***RE: Rifle Pit #1, File No.M-2020-008, Contruction Material Regular (112) Operation Reclamation
Permit Application, Comment Received***

Scott Contracting has submitted an application for a 112 permit in the name of Rifle Gravel Pit #1 to the Div. of Reclamation Mining and Safety- Mined Land Reclamation Board. (M2020-008) ACY/THM

Figure 3. Exhibit C - Affected Lands and Roads

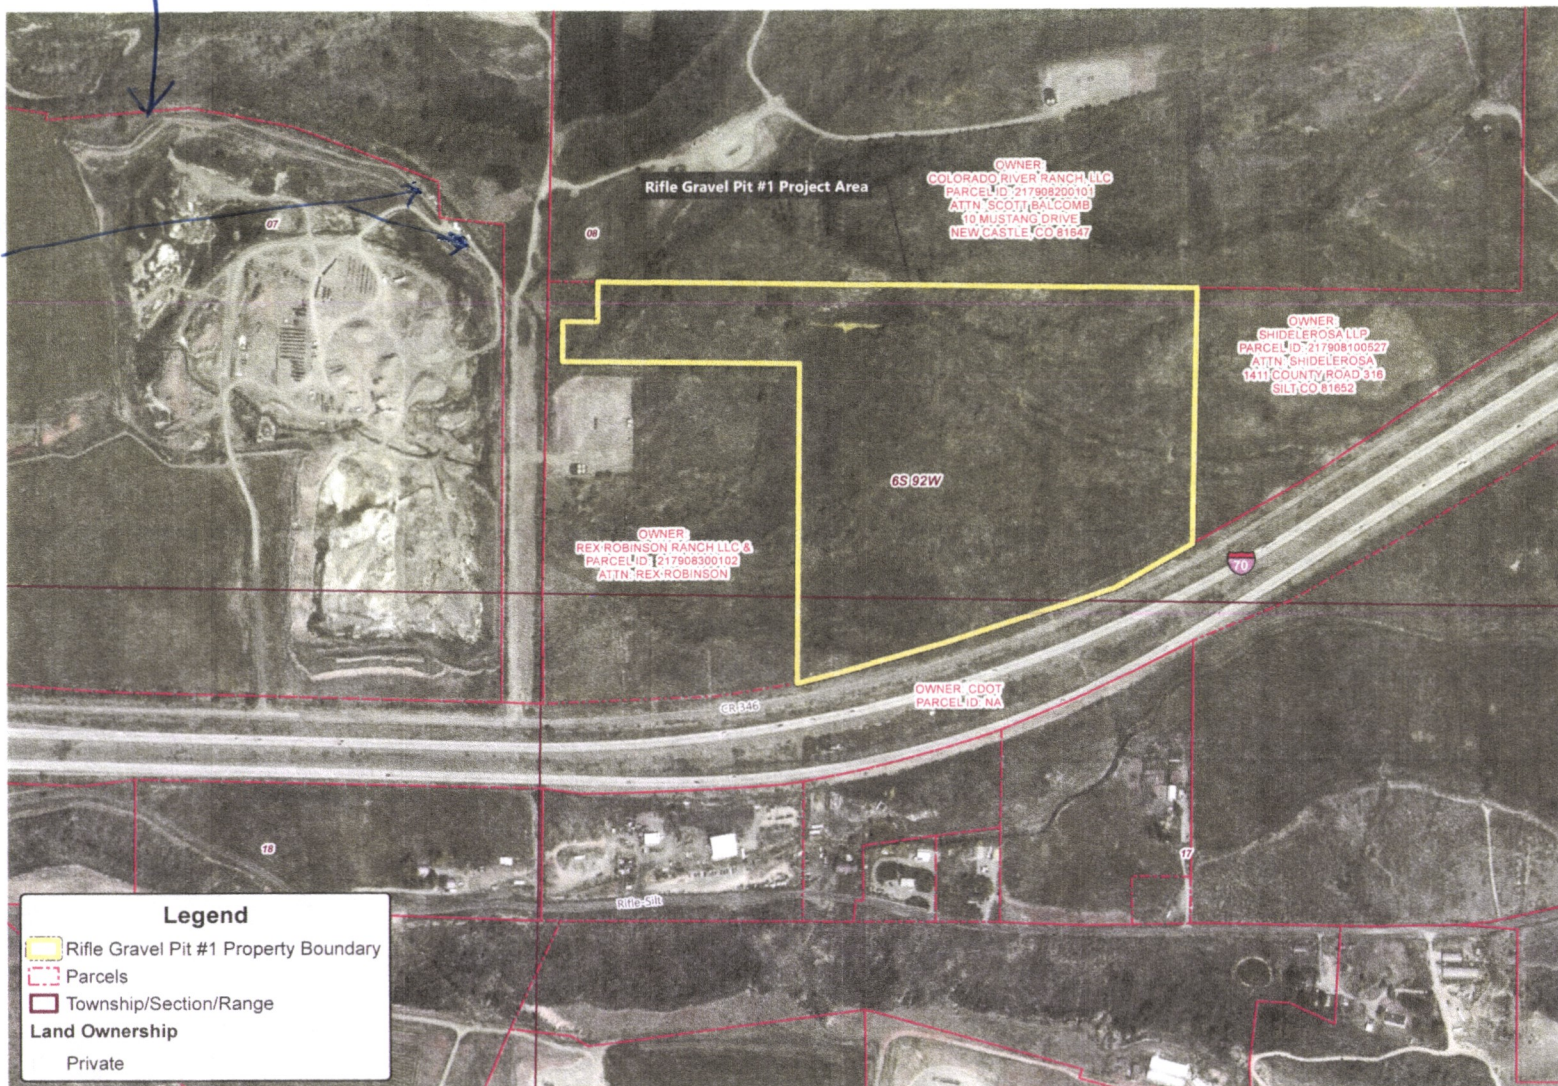
First and foremost the application states that the dewatering well will discharge into an onsite existing tailwater ditch that reaches the Colorado River. The water pumped to this tailwater ditch goes across our property in two places and parallels the north boundary of our property to eventually get to the Colorado River. This ditch has a flow that rises and falls with the seasons very little in winter months and an increase in the irrigation season that is irregular tailwater flow. The applicant has no permission to use the ditch that crosses our property for dewatering purposes. Pumping water to dewater a gravel pit is year round and could possibly be perpetual if an evaporative loss replacement contract cannot be obtained at the end of mining. The pumping of ground water to the ditch that was dug years ago to remove surface water from running across our property originating east of us is not an appropriate use nor do I believe a legal use and it is not acceptable in any way. Pumping more water to the ditch increases the flow raises the water level in the ditch and will increase the amount of infiltration into the gravel pit resulting in more cost to dewater our pit and may affect our reclamation of the pit walls resulting in injury to our property and gravel pit operation. Nowhere in the application is there an estimate or projection of the

Grant Bros. property line (red) approx.

Drain Ditch
Crossing our
property
along pit.

Figure 4. Exhibit C – Creeks, Waterways, and Wells

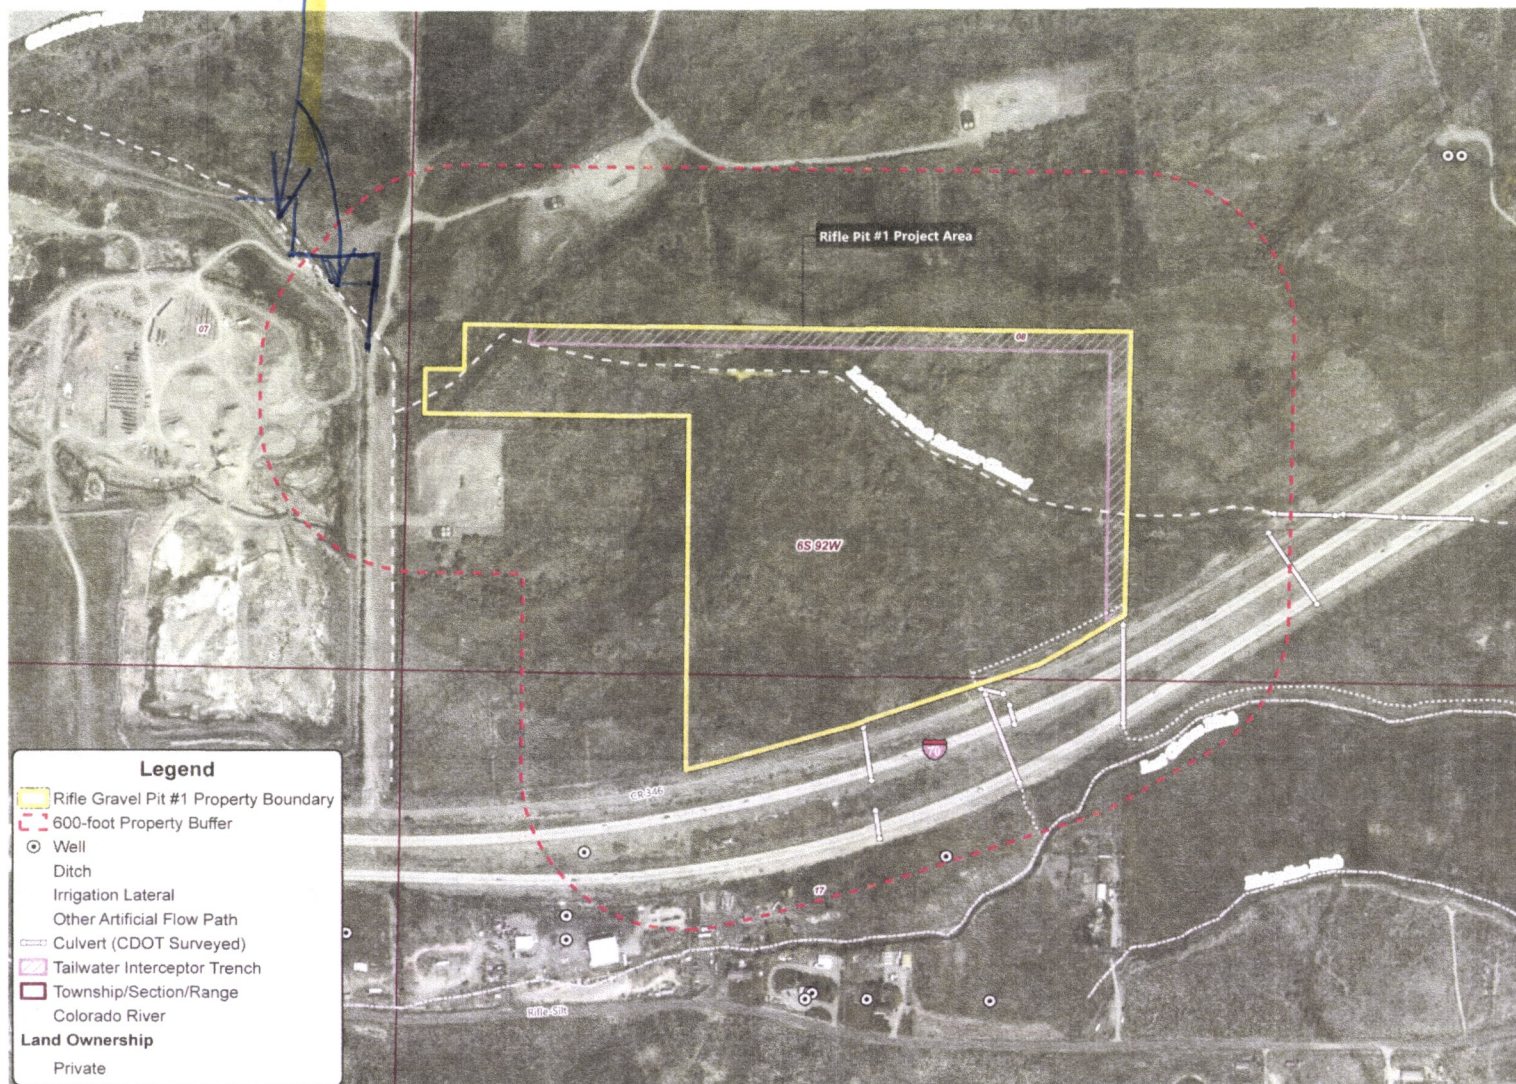
Drain Ditch on our property and along East & North boundaries.

Figure 9. Exhibit D Mining Plan

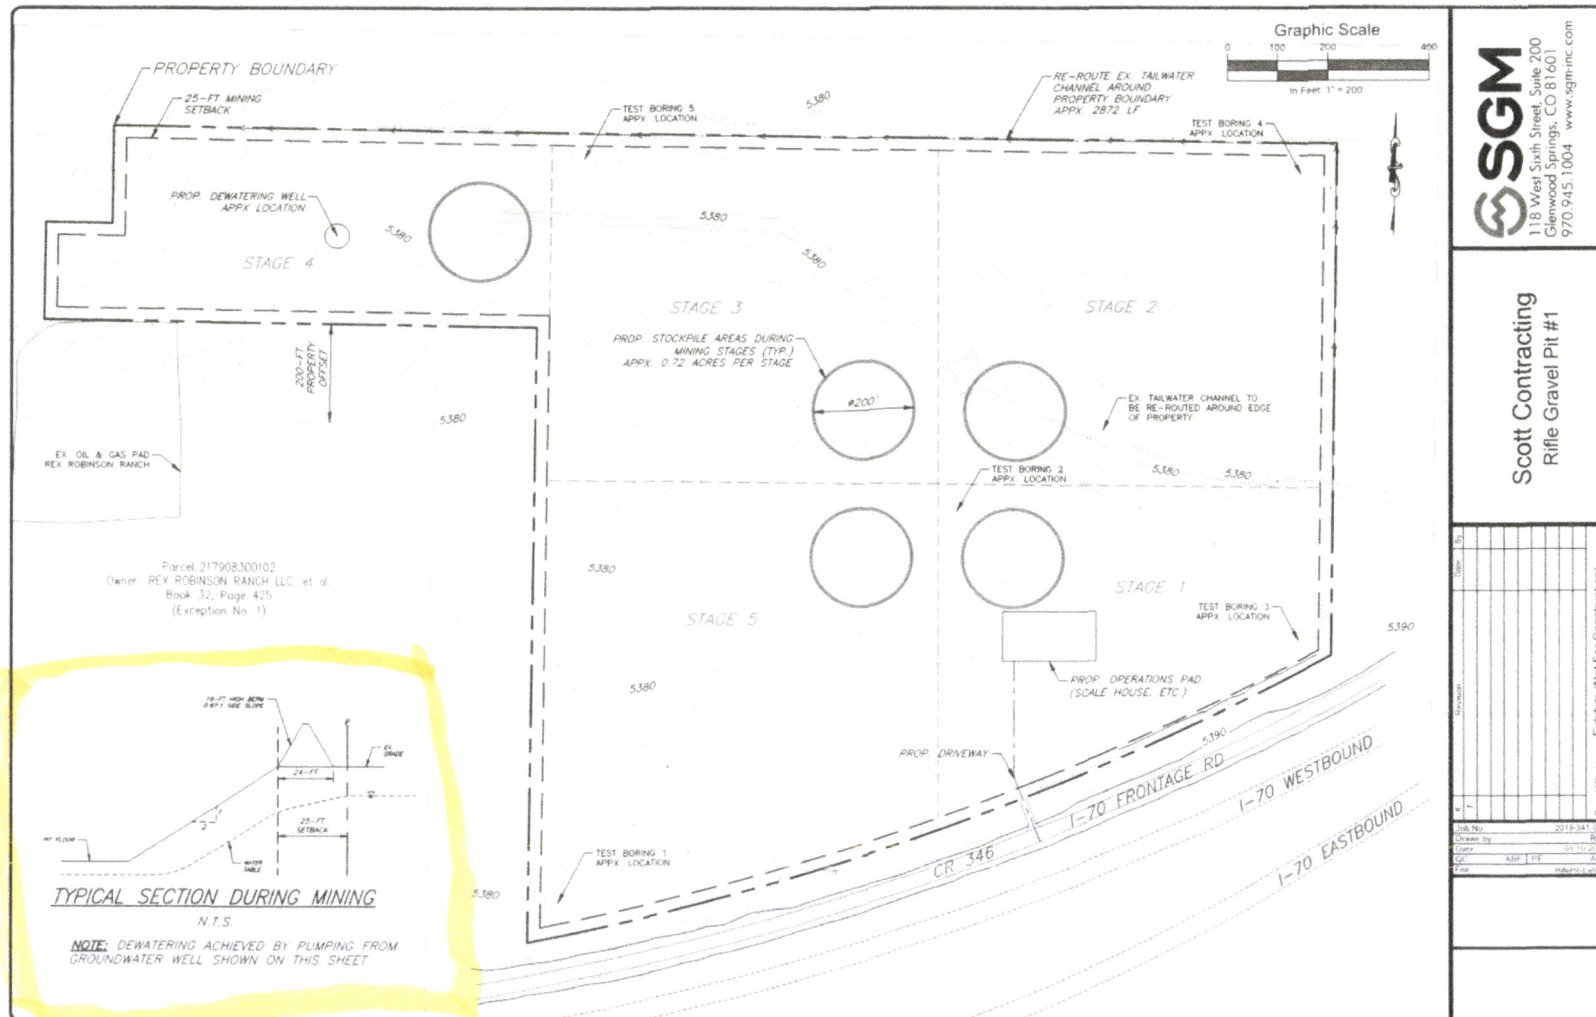
The rerouting of the water on the property to a ditch along the perimeter of the property within the 25 foot buffer is problematic in that there is going to be a stockpile of soil 24 feet at the base in the buffer strip leaving only 1 foot for a ditch between the property boundary and the stockpile. There is no room for maintenance of the ditch by machine or by hand without getting on the adjacent property. Is a 1 foot ditch sized large enough for the normal tail waters on the property? The application pictured water is a sump that holds water to soak in and does not flow completely across the property allowing water to spread and soak after the sump. The water flow in this 1 foot ditch as designed will flow on to the adjacent property in the event of a plug or ditch bank wash out. In a storm event will the runoff from the soil piles flow into the ditch plugging it and flow water and mud onto the adjacent property? How will you clean this up from your property? This event would put the operator in violation of his stormwater permit .Would the applicant be able to secure a stormwater permit with the design as purposed in a 25 foot buffer? I don't think so if the water quality control div. sees and visualizes this as built on the ground.

This shows a 24' base for soilpile in the 25 foot buffer just above and on the edge of the vertical pit wall as high as 20 foot plus.
